Government of the District of Columbia
DDOT/Urban Forestry Administration

Memorandum

Subject: BZA # 17309 – Application By Dorchester Associates, LLC.
DDOT/UFA Review of Recently Submitted Material & Statements

Figure 1 (Brady, Nyle C. and Ray R. Weil, 1999. *The Nature and Properties of Soils* – 12th edition. Prentice Hall, Upper Saddle River, NJ, 881 pp. page 193)

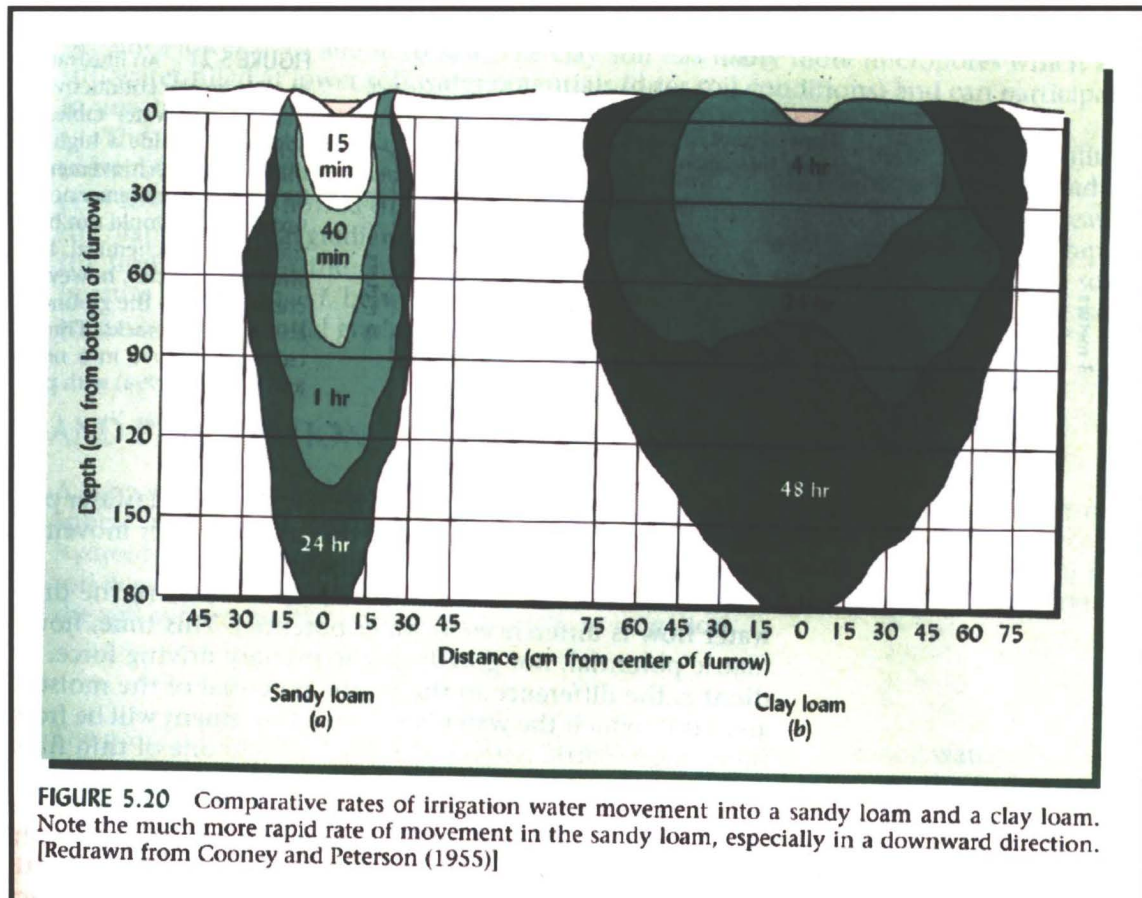
The above statement seems to have provided the conceptual framework that justifies the use of unexcavated platforms as a means to avoid damaging the critical root zones of the adjacent mature trees. This statement, however, is not true. As a rule water, when

introduced to a soil context, moves primarily in a downward direction. The following chart clearly depicts the behavior of water in soil over time:

The lateral movement of water through soil is governed largely by two factors: the slope & the percentage of clay contained in the soil. Most of the areas where unexcavated platforms have been proposed are relatively flat. Hence, we are limited in the extent to which we could expect the natural topography to redistribute water which has fallen in one location to another, which presumably is no longer in a position to intercept natural precipitation due to its impervious cover. This leaves soil composition as the next most important factor in determining the level of lateral water movement through the soil.
